Office Action Summary	Application No. 10/541,478	Applicant(s) VIRVING, NILS	
	Examiner Bena Miller	Art Unit 3725

Claims 5 and 10 are rejected under 35 U.S.C. 102(b) as being anticipated by Reinhall (US Patent 5,042,726).

Figure 3 of Reinhall

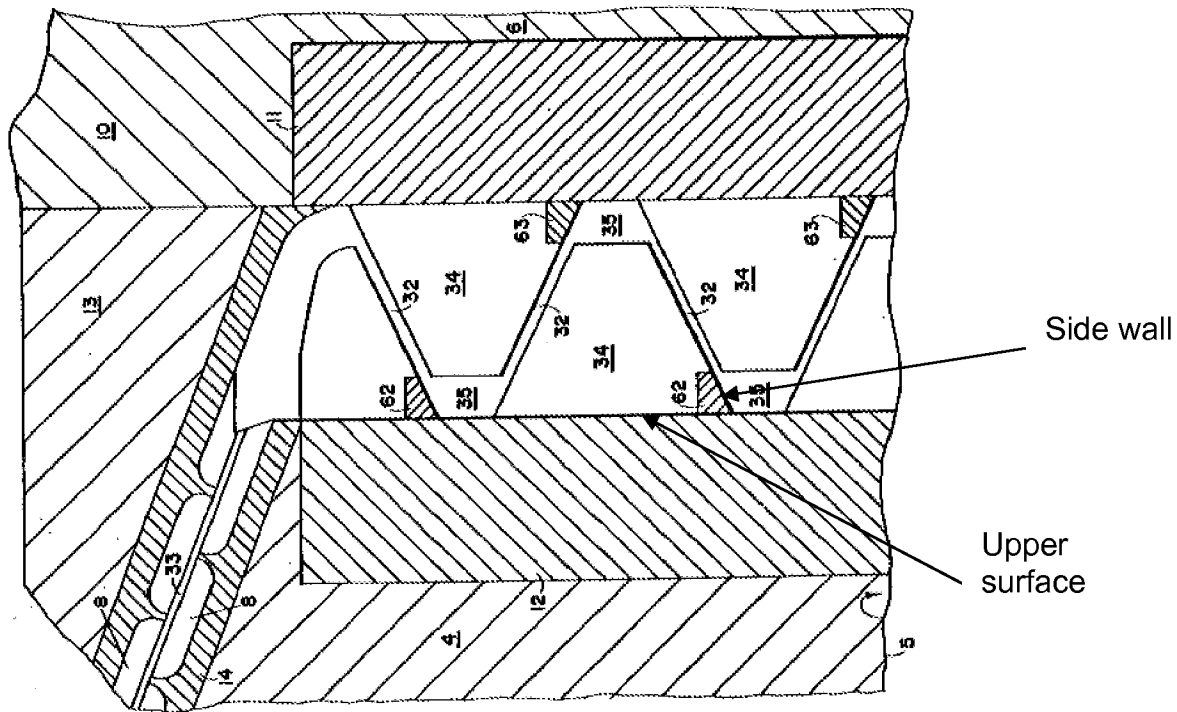
The device of Reinhall teaches the limitations of the claimed invention including an inner rotary refining member including an outwardly facing conical surface (12 and 14) and a second refining member comprising an outer stationary refining member including an inwardly facing conical surface (11 and 13) mounted in juxtaposition with said first refining member whereby said conical surfaces face either other and define a refining gap therebetween for refining said lignocellulosic fibrous material, said refining element adapted for mounting on said inwardly facing conical surface and including a plurality of bars (34) and intermediate grooves (35), said plurality of bars extending along said refining gap including a pair of side walls (fig.3) and an upper surface (fig. 3), said upper surface forming an acute angle with at least one of said pair of side surfaces (fig.3—see marked copy, Note: the upper surface forms an acute angle with one side of

the surface) and the upper surfaces forms acute angle with both of the pair of side surfaces.

Reinhall teaches most of the elements of the claimed invention, except for the acute angle between 50° to 90° , 60° to 90° , 70° to 90° and at least one side surface includes at least about on-third portion of the total height of the. Regarding claims 6-8, it would have been obvious to one of ordinary skill in the art to have the acute angle of the upper surface of Reinhall between the claimed angles, noted above, and at least one side surface having least about on-third portion of the total height of the bars for the purpose of allowing a simultaneous adjustment of the width of the gap spaces between the rotatable and stationary refining members.
